Addendum 4 - VI Mitigation Work Plan

South Dayton Dump and Landfill Site
Moraine, Ohio

Submitted to:
US EPA Region 5
Emergency Response Branch
Cincinnati, OH
OSC Steve Renninger

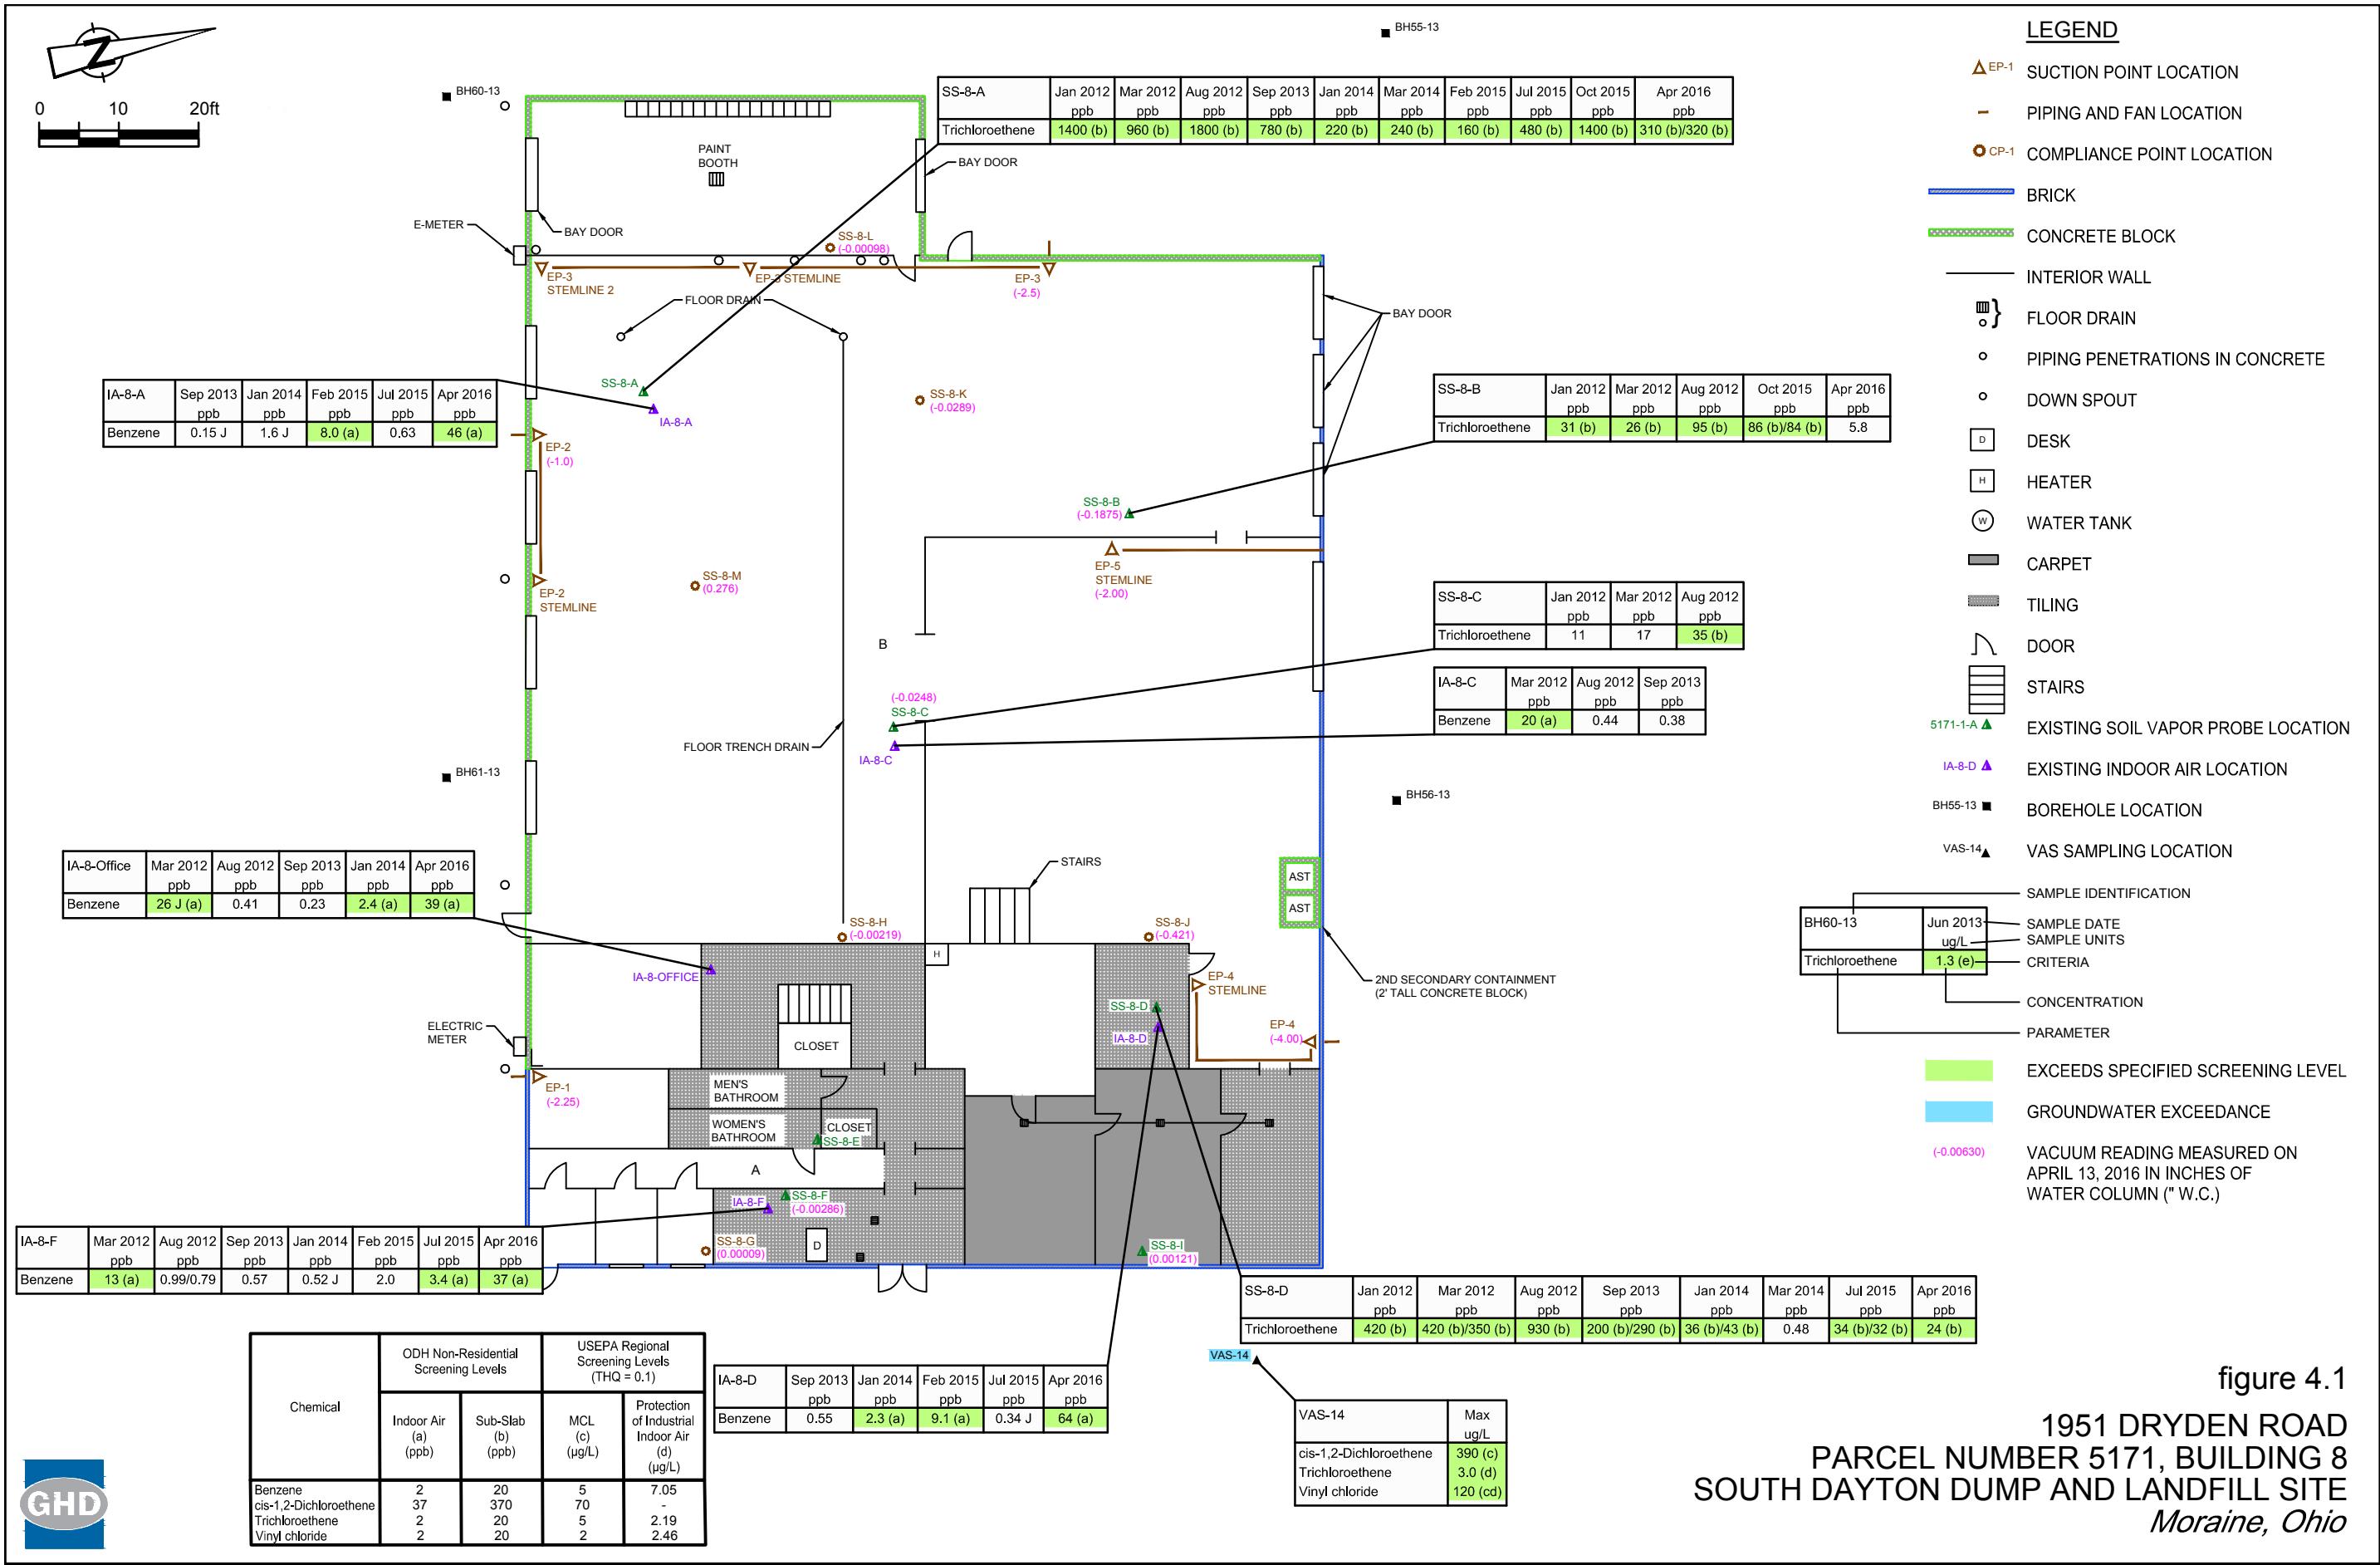
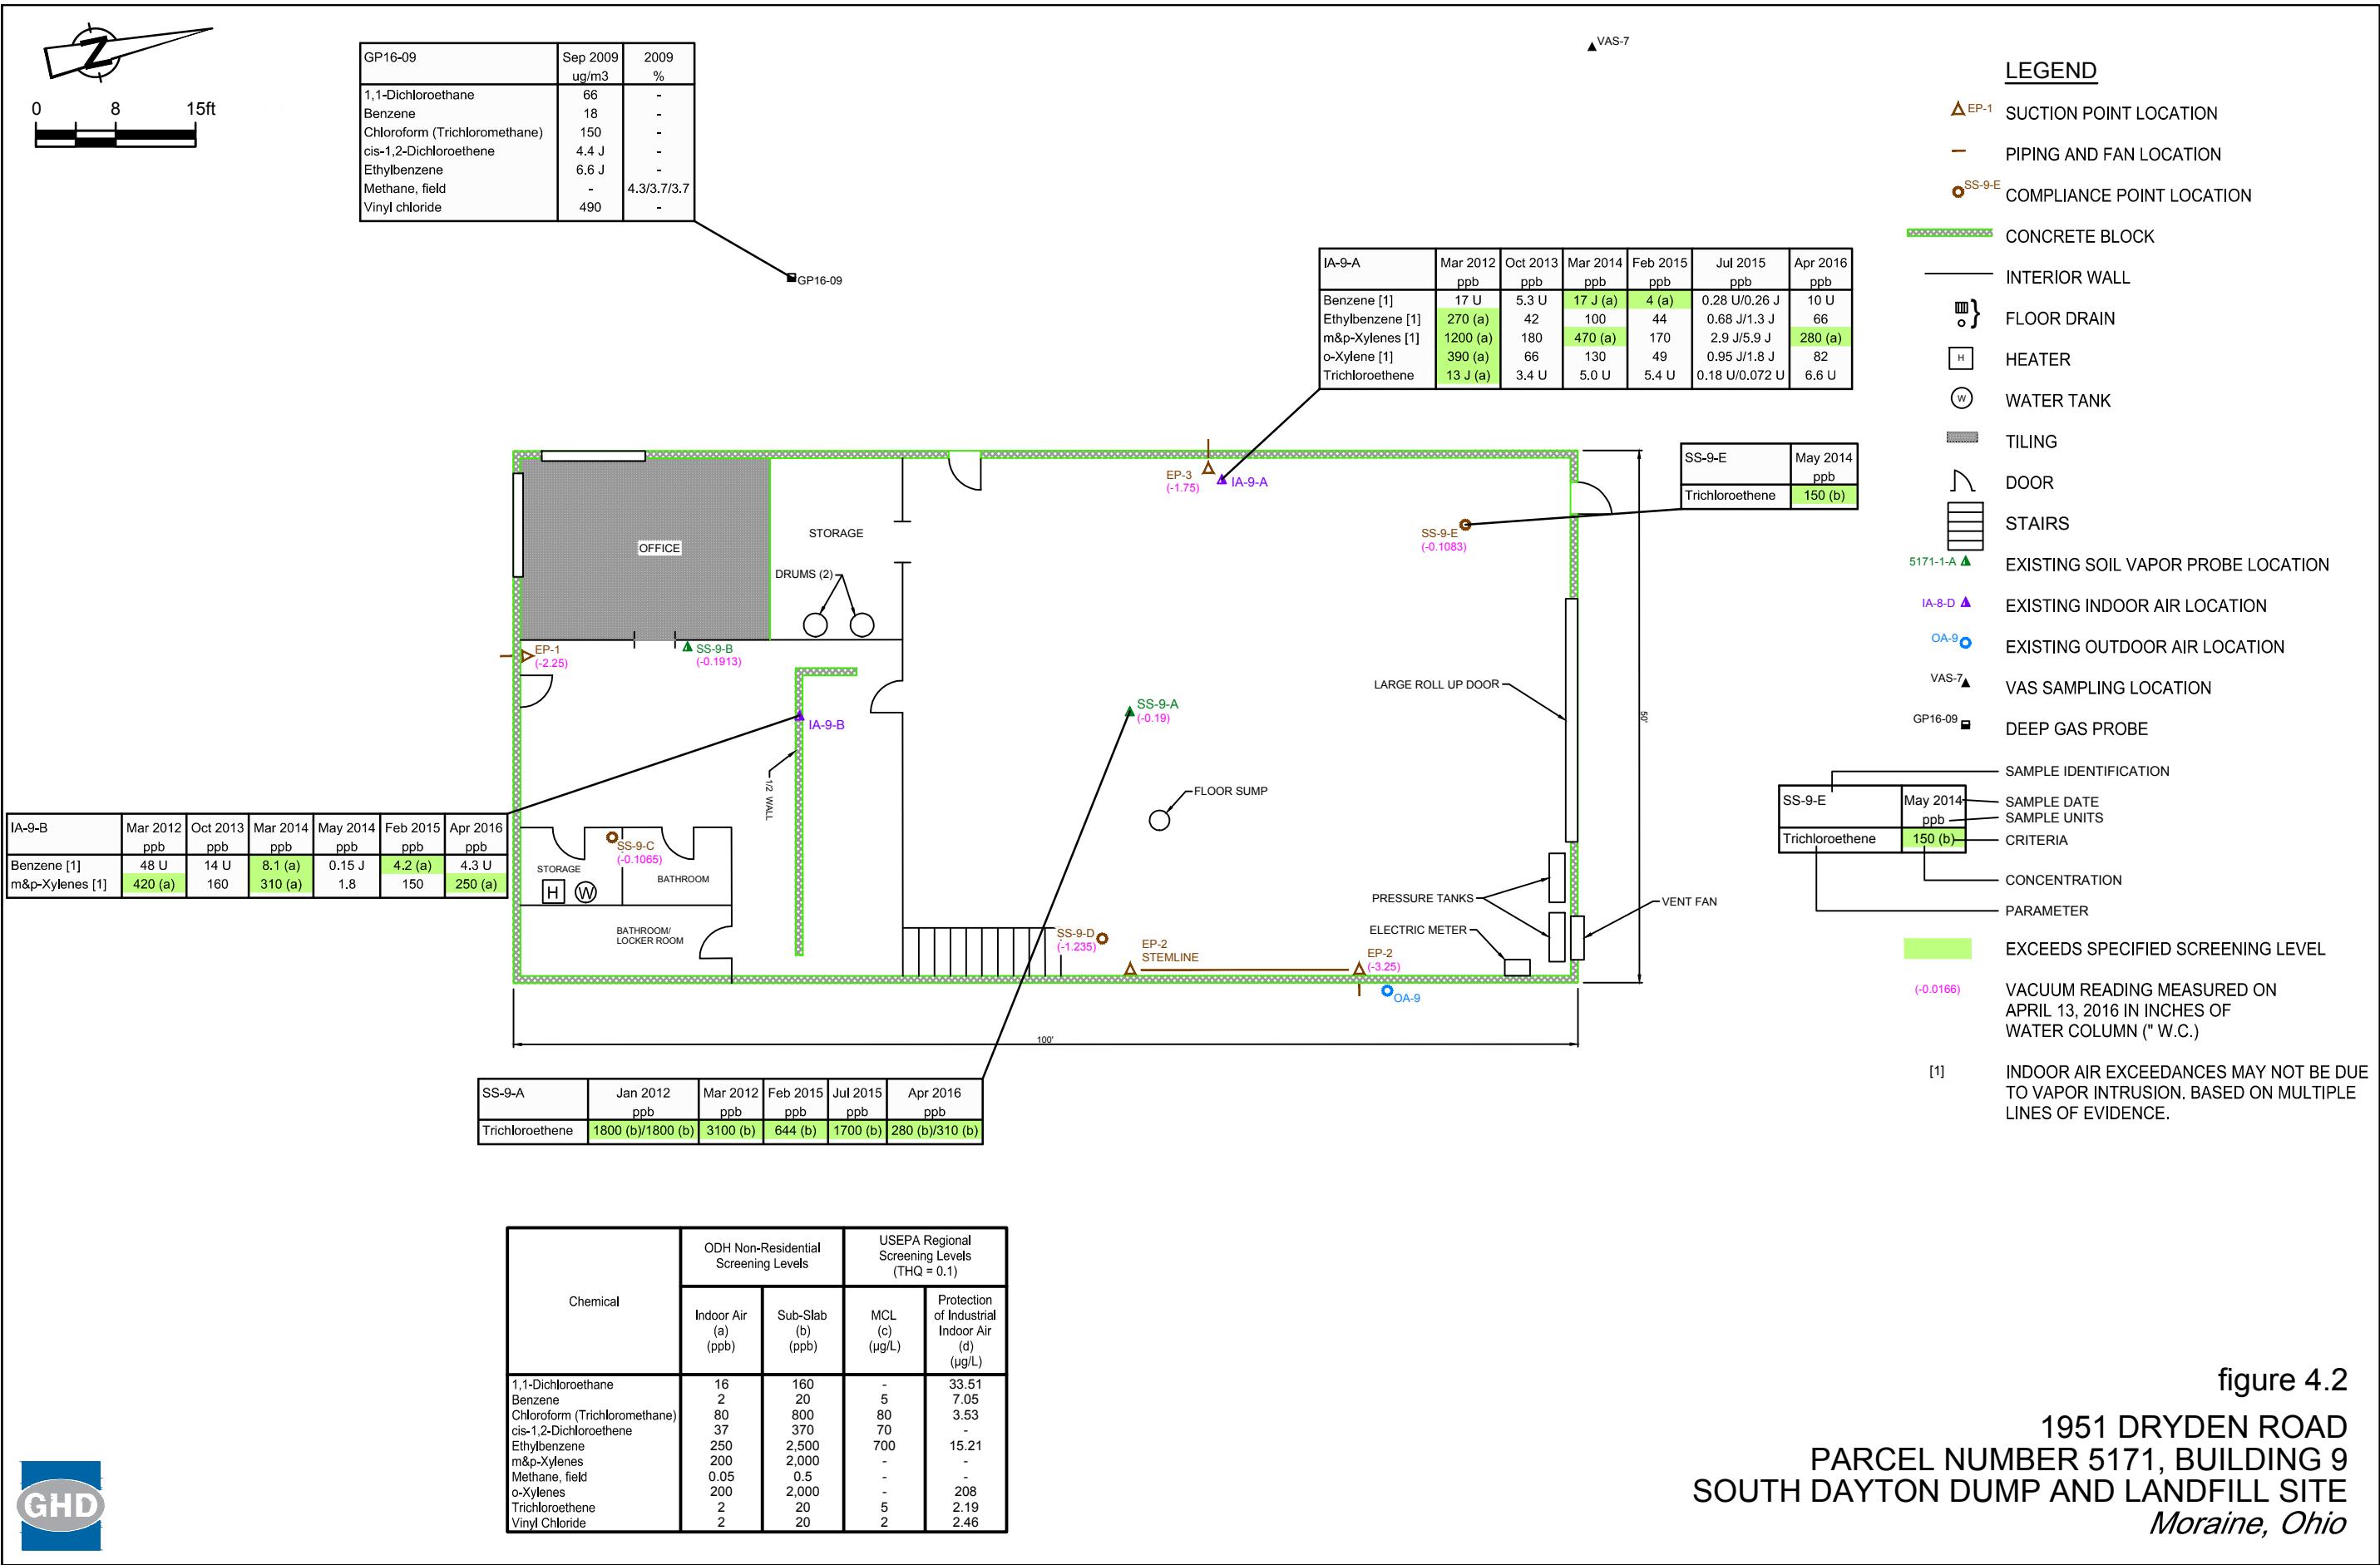
Although the SS concentrations in Buildings 8, 9, and 12 remain greater than ODH screening levels, the concentrations have decreased significantly in comparison to the pre-mitigation results, with the exception of Building 12 - Overstreet Painting¹(see Figures 4.1 to 4.3). On a VI conference call held

Proposed annual sampling locations for all buildings are presented in Table 1, and on Figures 4.1 to 4.7. The USEPA will have the opportunity to approve or modify the proposed locations and may elect to collect split-SS samples or to collect SS or IA samples at other locations.
